**GOVERNMENT OF THE DISTRICT OF COLUMBIA
DEPARTMENT OF CONSUMER AND REGULATORY AFFAIRS
OFFICE OF THE ZONING ADMINISTRATOR**

January 28, 2013

Re: 1111 19th Street, NW, Washington, D.C. (Square 140, Lot 90)
Confirmation of Permissible Gross Floor Area of Building

First Floor Depiction -- Modifications to Re-allocate Gross Floor Area.

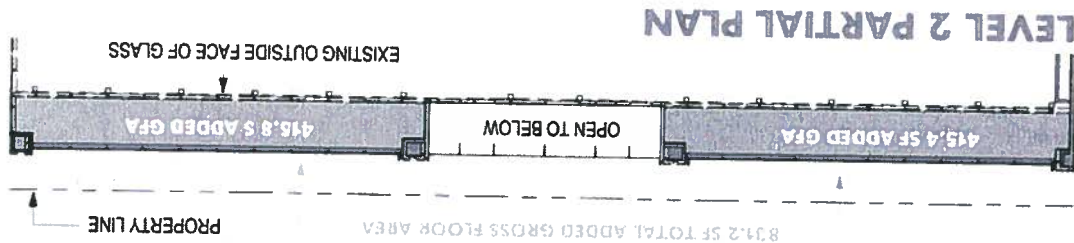
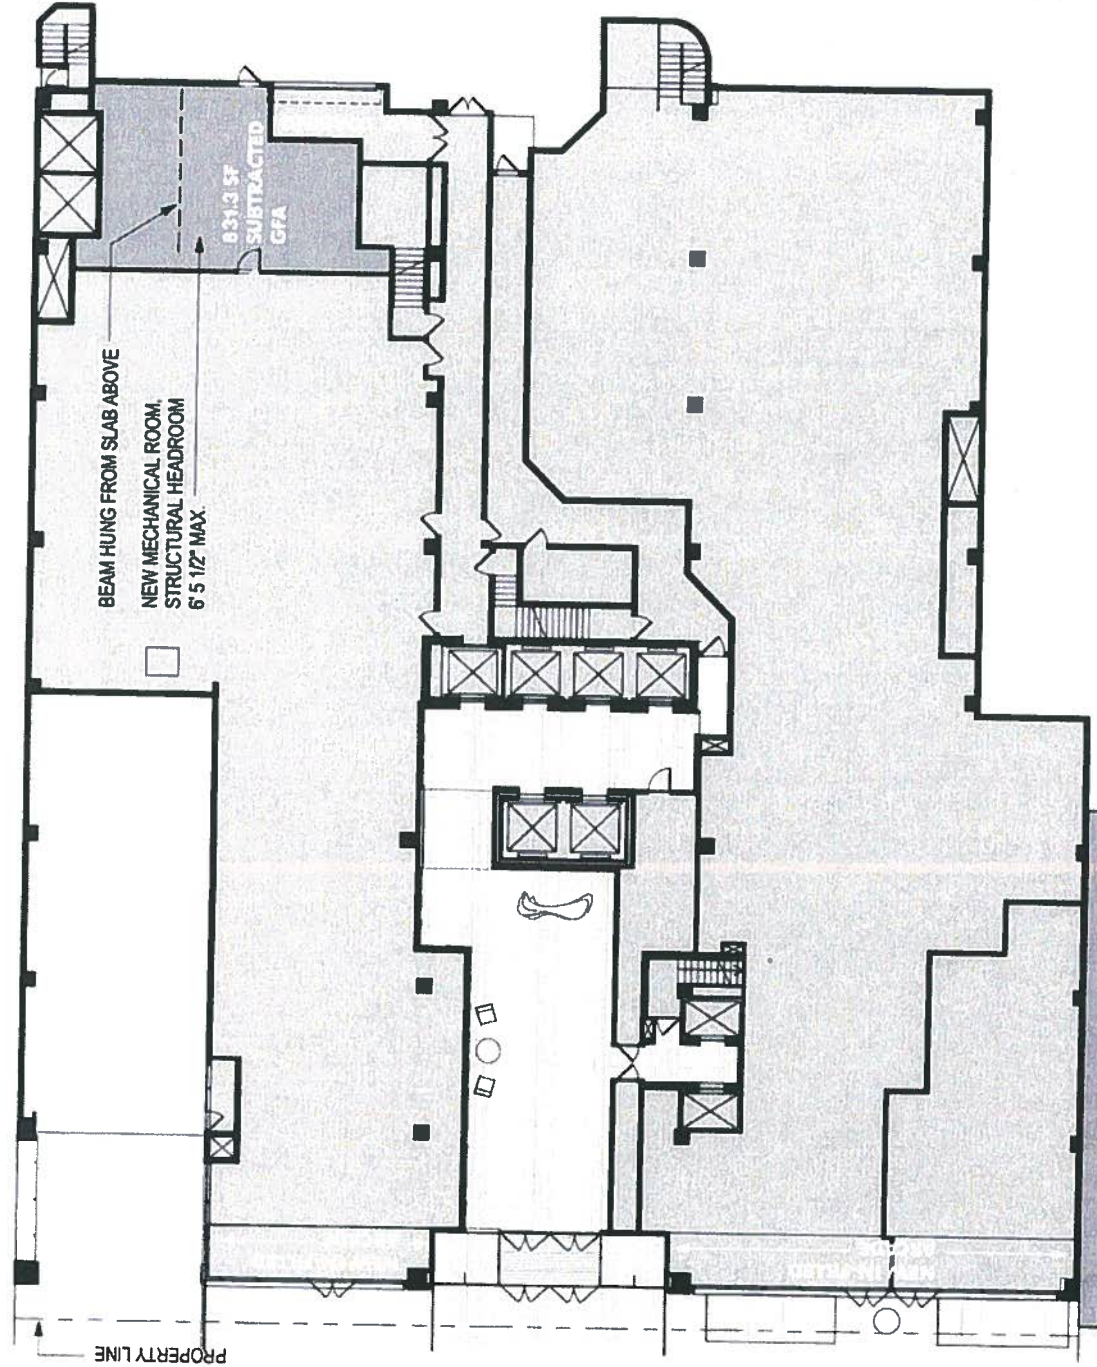
You provided a depiction of a plan of the first floor of the 19th Street Building identifying where floor area on the first floor would be eliminated as floor area chargeable against gross floor area by conversion of this area to mechanical space supporting the operations of the first floor with a reduction of measurable height in this space being less than 6 feet 6 inches. This depiction also reflects that the floor area relieved by this conversion would be sufficient to permit the extension

of portions of the 2nd floor to the column line independent of extension of the first floor pursuant to Section 2524 of the Zoning Regulations. [Depiction attached as Enclosure 3.]

1. The first floor of the building, including any 2 story component thereof (i.e. a 2 story entrance foyer/lobby), can be extended to the 19th Street Building column line, and any additional floor area created by such extension would not increase the amount of gross floor area of the Building, pursuant to the provisions of Section 2524 of the Zoning Regulations; and,

2. The second floor of the building may be extended to the 19th Street Building column line, provided that an equal or greater amount of floor area that would be consumed by that extension would be removed from another portion of the Building chargeable as gross floor area. The proposal to convert a portion of the first floor to mechanical space with a reduced ceiling height of less than 6 feet 6 inches as depicted in the attached diagram removes sufficient amount of floor area to free up gross floor area, which can then be incorporated into an expansion of the 2nd floor to the 19th Street Building column line without being integrated into the space of the 1st floor extension.
